**City of Port Colborne
Council Meeting Addendum**

7.1. Port Colborne Municipal Drain Meeting to Consider, 2021-211

Port Colborne Drain

Response to Port Colborne Municipal Drain Report
Report to Council PWD 2021-148, June 14, 2021
EWA Project # EWA-189999 Dated April 16, 2021

Figure 1 from Engineer's Report, with original Drain names

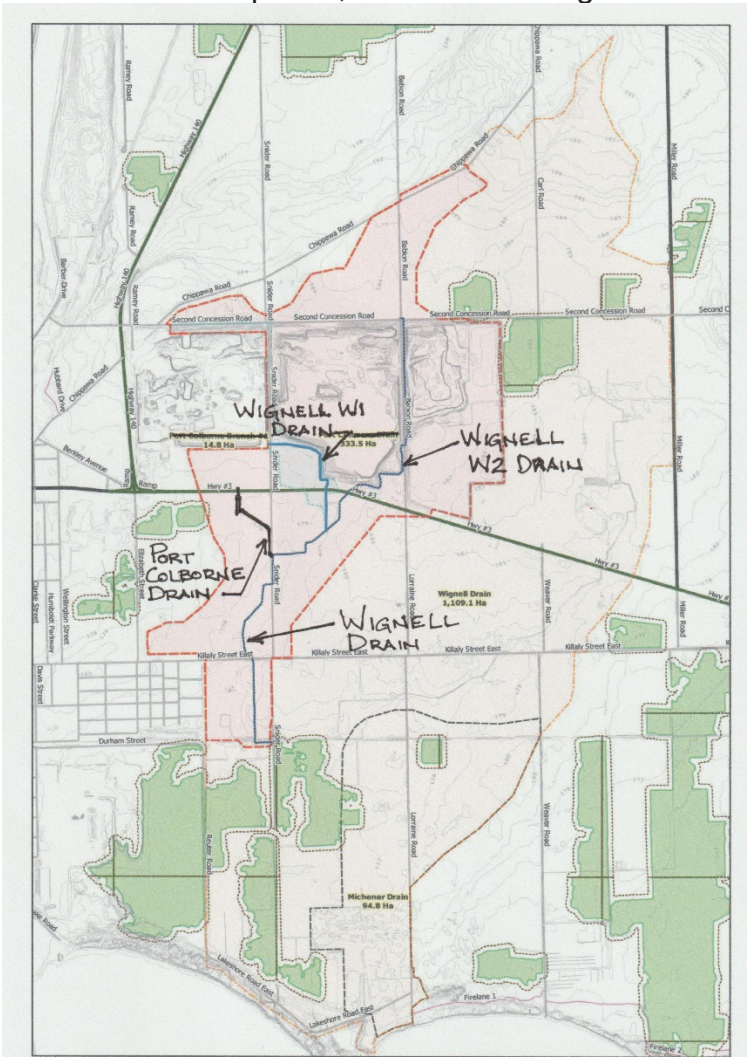
When this Report suggests the renaming of the Wignell Drain Branches W1 and W2, to Port Colborne Drain, they are using a name which is still in use to identify a different Municipal Drain. The original Port Colborne Drain extends north about the middle of Lot 23, Concession 2, branching from the Wignell Branch Drain, from Killaly Street to Hwy #3, and crosses Hwy #3 from the south side to the north side between Elizabeth Street and Snider Road. This drain receives water from the area on both sides of Snider Road north of Hwy #3, and the field north of Hwy #3 on Lot 23, Concession 2. See Figure 1 below. In this response, I will use the original Drain names.

For the Wignell W1 Drain, there is at least one property missing on the assessment schedule. This is the third house north of Hwy #3. In my opinion, the overall watershed area should be equal to the total of the individual properties. The current direction of flow also indicates most of the area of the properties on Snider Road should be assessed to the original Port Colborne Drain.
